Application of LS Power Grid California,
LLC (U-247-E) for a Certificate of Public
Convenience and Necessity Authorizing
Construction of the Collinsville 500/230 kV
Substation Project

A. 24-07-018 (Filed July 30, 2024)

**PREPARED TESTIMONY OF EXPERT DEBORAH GALIMBA
ON BEHALF OF CALIFORNIA FOREVER**

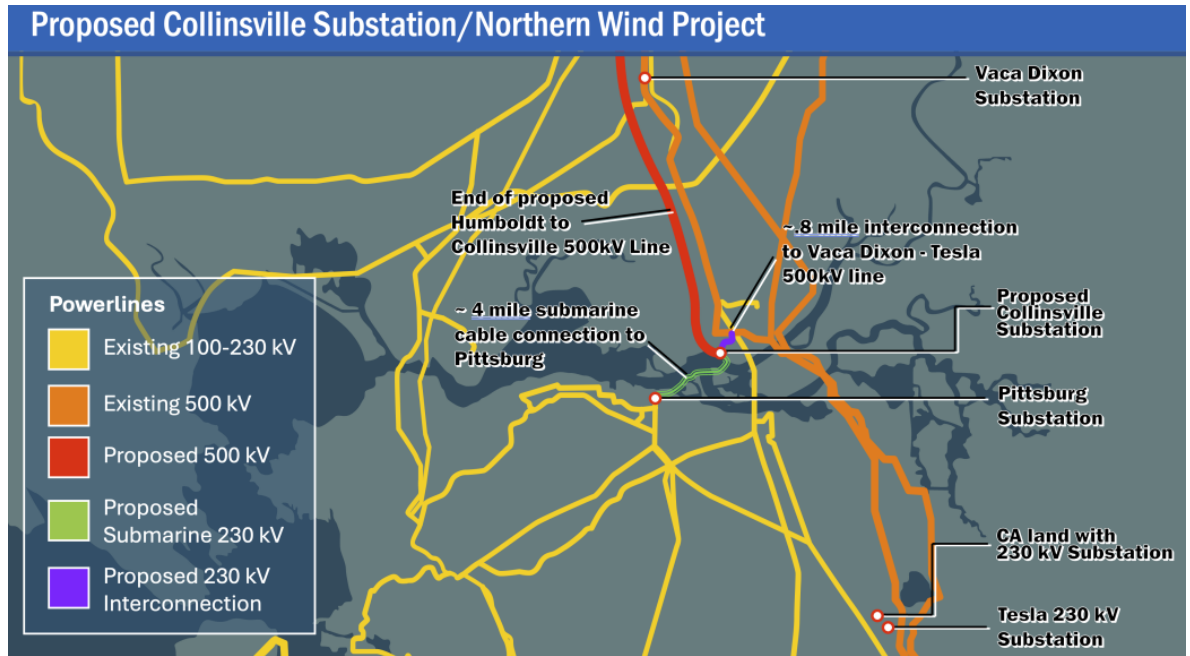
5
 6
 7
 8
 9
 10
 11
 12
 13
 14
 15 As shown above, the Collinsville Substation is proposed in a remote location in tidal
 16 wetlands in the Sacramento-San Joaquin Delta. The California Department of Fish and Wildlife
 17 (CDFW) has already recommended relocating the Substation in its December 17, 2025 DEIR
 18 comments due to documented impacts on the salt marsh harvest mouse and migratory bird habitat.

5 **Image 5** (the Vaca Dixon and State and Tesla substations are sited near the Vaca Dixon-Tesla
6 500 kV line. They are also close to the existing Contra Costa-Newark and Pittsburg-Tesla 230 kV
7 lines to the west).

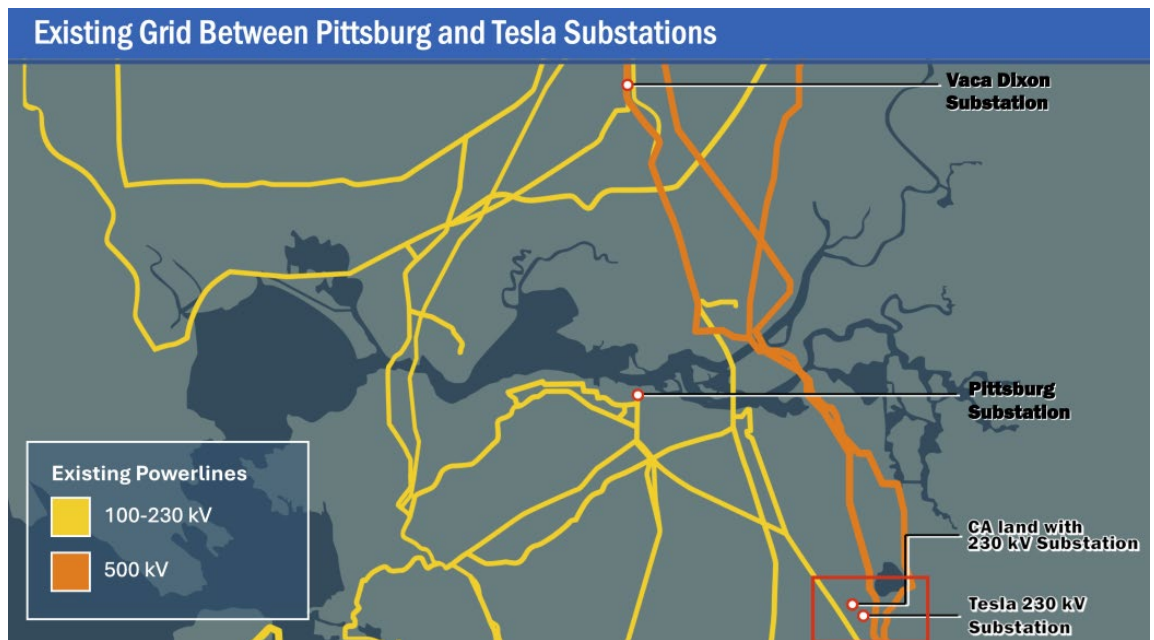
8 The Project and the reconductored Pittsburg-Tesla lines share the same hub: the Pittsburg
9 Substation. The Project feeds power into that hub from the north via submarine cable; the
10 reconductored lines carry power out of that hub southward toward the Contra Costa-Newark corridor.
11 CAISO identified the Project in its 2021-2022 Transmission Plan to relieve overloads on that
12 downstream corridor. Yet, the record does not demonstrate that the additional thermal capacity
13 created by the 2013-2015 Pittsburg-Tesla reconductoring was modeled or credited against the
14 identified Contra Costa-Newark constraint before the Project was identified. This represents a
15 material analytical gap in CAISO’s planning process.

16 If already-reconductored lines provide sufficient incremental capacity to resolve the identified
17 overloads under current and near-term load conditions, the Substation in a tidal wetland, with 4.5
18 miles of submarine cable beneath the Sacramento River, cannot be justified as the least-cost, least-
19 environmental-impact solution. The Commission should require the project proponent and/or CAISO
20 to produce a sensitivity analysis demonstrating the residual constraint that exists on the Contra Costa-
21 Newark 230 kV corridor after full credit is given for the capacity added by (i) the Pittsburg-Tesla
22 reconductoring, as well as (ii) the emergency of new battery energy storage systems (BESS)
23 (standalone or co-located with utility-scale solar projects) in generation load centers, like the Central
24 Valley.

1 **Image 6** (suggests two possible alternative interconnections between the Vaca Dixon-Tesla 500 kV
2 line and adjacent East Bay 230 kV grid via either the State and Tesla substations via shorter distances
3 over flat farmland.

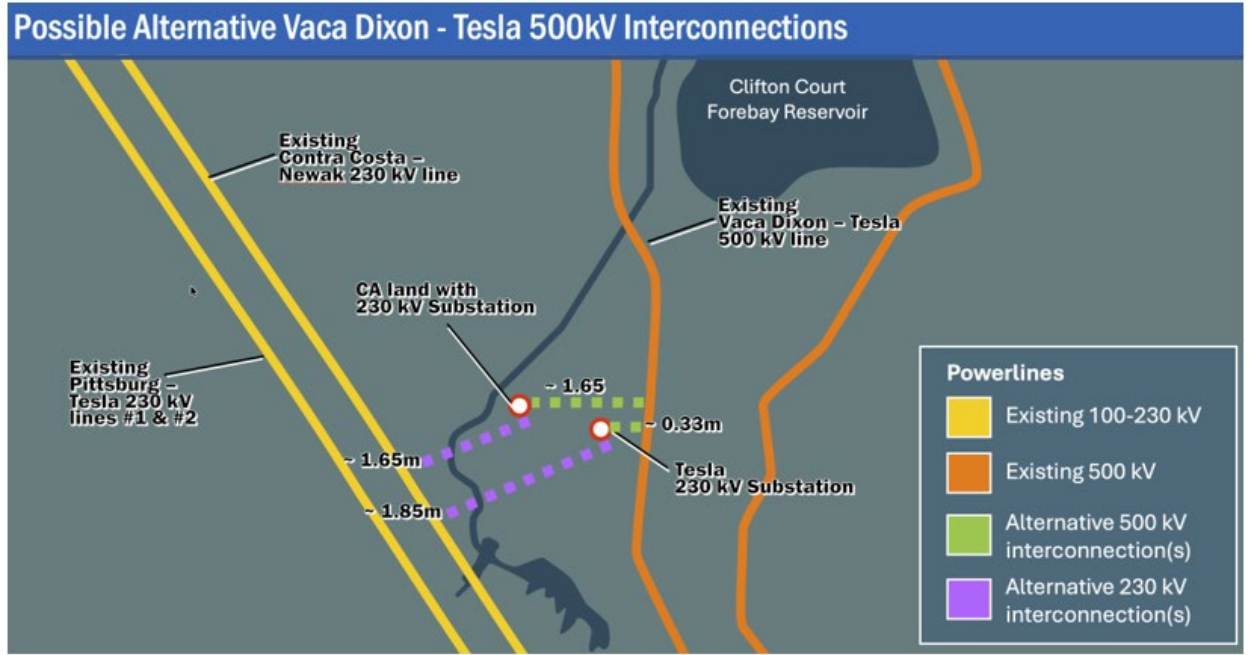
4
5
6
7
8
9
10
11
12
13
14
15 Utilizing the existing Bethany Gas Compressor 230 kV substation as an interconnection point
16 would allow new capacity to be injected into the 230 kV network at a location that is already within
17 the stressed corridor, on already-permitted and already-disturbed land, without new rights-of-way,
18 without submarine cable beneath the Sacramento River, and without any construction in the
19 Sacramento-San Joaquin Delta tidal wetlands that have driven the California Department of Fish and
20 Wildlife’s relocation recommendation. This alternative would be subject to the same N-1 and N-1-1
21 contingency analysis and load flow modeling that CAISO applied in approving the Project. Neither
22 LS Power nor CAISO has considered or evaluated this substantially less costly and environmentally
superior alternative.
